SACRAMENTO MUNICIPAL UTILITY DISTRICT  
The Power To Do More.™

Docket No. 50-312  
Rancho Seco Nuclear Generating Station  
License No. DPR-54

**RESPONSE TO NRC REQUEST FOR ADDITIONAL INFORMATION**

## Response to RAIs Dated February 27, 2007

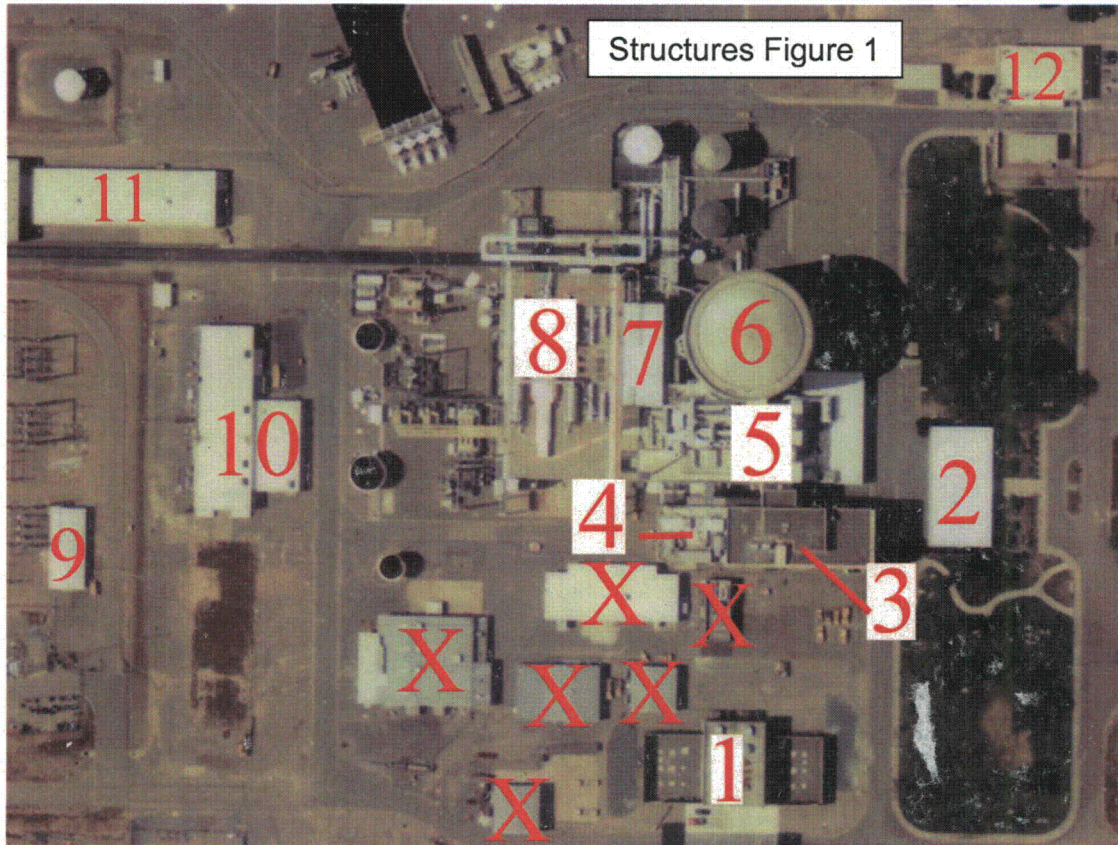
- b. Please describe the approximate acreage of the site occupied by infrastructure (e.g., buildings, roads, parking lots) prior to decommissioning and what that acreage would be after the site is released from NRC licensing.

The acreage of the site occupied by infrastructure (e.g., buildings, roads, parking lots) will not change after the site is released from NRC licensing. The majority of the infrastructure is contained within the existing 87-acre Industrial Area. The only exceptions are the Hazardous Material Warehouse, the Receiving Warehouse and portions of the paved site access road. The Hazardous Material Warehouse will be demolished down to its concrete pad prior to completion of the first phase of license termination. The fence enclosing the Industrial Area will not be removed during decommissioning. Upon completion of the first phase of license termination the Industrial Area will be maintained as an industrial site with access controlled by the SMUD Asset Protection Department (industrial security). The Interim Onsite Storage Building (IOSB), which will remain under the 10 CFR Part 50 license, will be contained within this industrial site. The Backup Control Center (BCC) in the former Administration Building, the Training and Records Building with occupied offices and the active switchyard will also be contained within this industrial site. The Independent Spent Fuel Storage Installation (ISFSI), which is licensed under 10 CFR Part 72, is accessible only from the industrial site. No existing roads or parking lots will be removed during decommissioning. Upon completion of the second phase of license termination, access to the industrial site will continue to be controlled by the SMUD Asset Protection Department.

Before and after decommissioning aerial photographs of the Industrial Area are provided below.

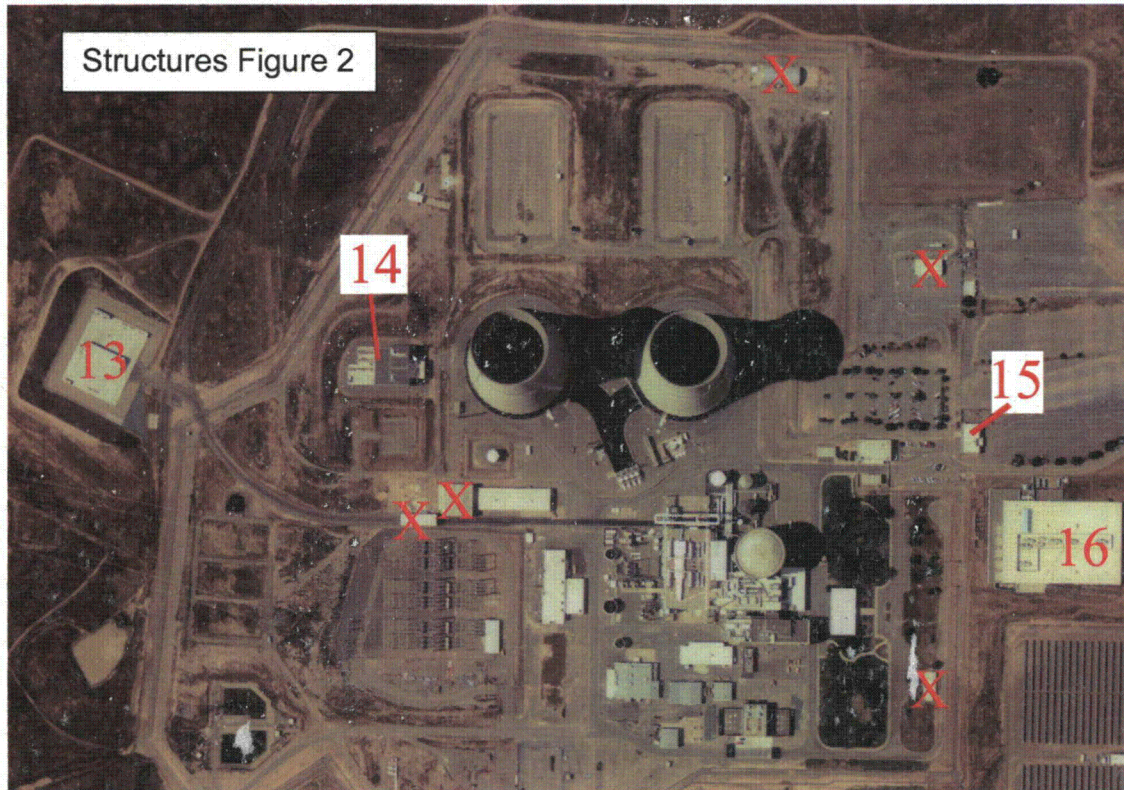
- d. Please provide a listing to clarify which specific structures will likely remain standing at the site after release from NRC licensing.

Most of the major concrete structures will remain in place. All paved areas will remain paved. Below are "Structures Figure 1", showing the buildings located near the power block, and "Structures Figure 2", showing the remaining structures in the vicinity of the Industrial Area. A red "X" indicates that the structure has or is scheduled to be removed, leaving only the concrete pad of the structure for Final Status Survey. Note that the cooling towers and cooling tower basins will remain following License Termination. All planned structure demolition will occur before Final Status Surveys are complete for the first phase of the License Termination Plan (LTP).

The following buildings shown in "Structures Figure 1" will remain after License Termination:

1. TDI Diesel Buildings
2. Back-up Control Center (formerly Administrative Building)
3. Training & Records Building
4. Nuclear Service Electrical Building
5. Auxiliary Building
6. Reactor Containment Building
7. Spent Fuel Building
8. Turbine Building
9. Switchyard Control Building
10. Machine Shop (includes area formerly known as the "A" Warehouse)
11. "B" Warehouse
12. Personnel Access Portal (PAP) Building

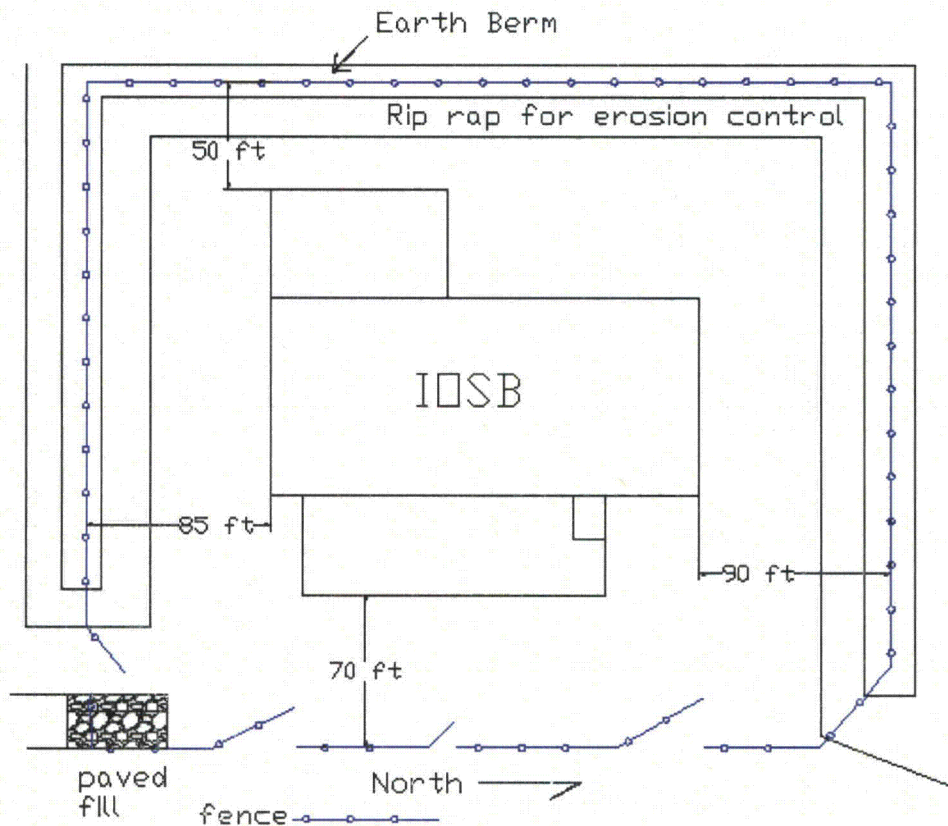
- b. Please identify the approximate area size and location of the fence line and gate for the portion of the site that will remain on the license with the IOSB and the relationship to the spent fuel storage area, including both the distances between the spent fuel and the IOSB fence lines. Also, indicate the location and expected readings for maximum radiation levels between the IOSB and spent fuel storage area. If the land between the spent fuel storage area and IOSB is not going to remain on the license, indicate the anticipated maximum radiation doses in this region where unrestricted release is occurring between the two fence lines and provide the analysis to assure that 10 CFR Part 20 public dose limits will not be exceeded (using dose contributions from the ISFSI, released area, and IOSB). Additionally, please identify these locations on a map or diagram.

The figure "Proposed IOSB Fence" below shows the building footprint and relative locations of the bermed area, the boundary fence, the gates east of the IOSB and the approximate distances of the fence lines to the nearest portions of the building. The total footprint that the 10 CFR Part 50 licensed site will occupy after Phase 1 of License Termination is encompassed by the rectangular area within the fence, and is approximately 300-feet east-to-west by 160-feet north-to-south. The total area is approximately 1.1 acres.

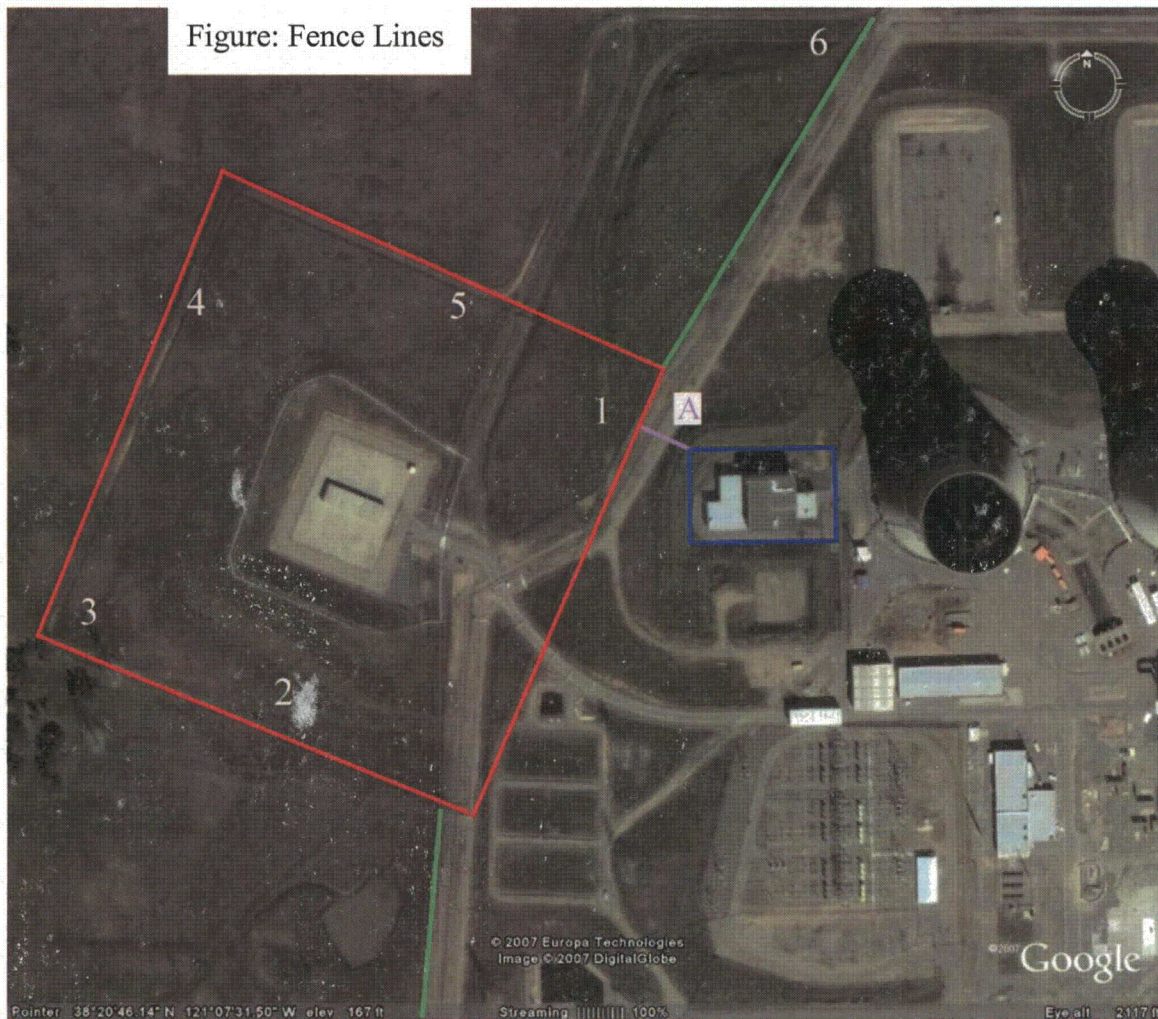
- c. Please identify access roads and paths that will continue to exist after the first phase of site release and will be located nearest to the new IOSB fence line, including location and distance from the IOSB. Clarify whether access to these roads and paths are controlled in some way or available for public access. Please include travel volume estimates for these roads and paths. Additionally, please identify the locations on a map or diagram.

The figure "Fence Lines" below indicates the approximate location of the fence line proposed for the IO SB (shown in blue) and the approximate location of the 100-meter fence that is in place around the ISFSI (in red). The green lines approximate the current outer portion of the industrial area fence that will remain in place. The purple line labeled "A" is the shortest distance between the IO SB and ISFSI fences, which is approximately 130 feet. Access to the area within the red lines is controlled by the 10 CFR Part 72 license. Access to the area within the blue lines will be controlled by the 10 CFR Part 50 License between Phase I and Phase II of License Termination.

The figures "Structures Figure 2" and "Fence Lines" included earlier provide aerial views of the areas around the IOSB. The nearest "road" would be the area just east of the IOSB, where the controlled access fence will be placed approximately 70 feet from the eastern wall of the IOSB. The road west of the IOSB is also at its closest point approximately 70 feet away from the North-West corner of the IOSB, but a berm separates the building from the surrounding areas on all sides but the East.
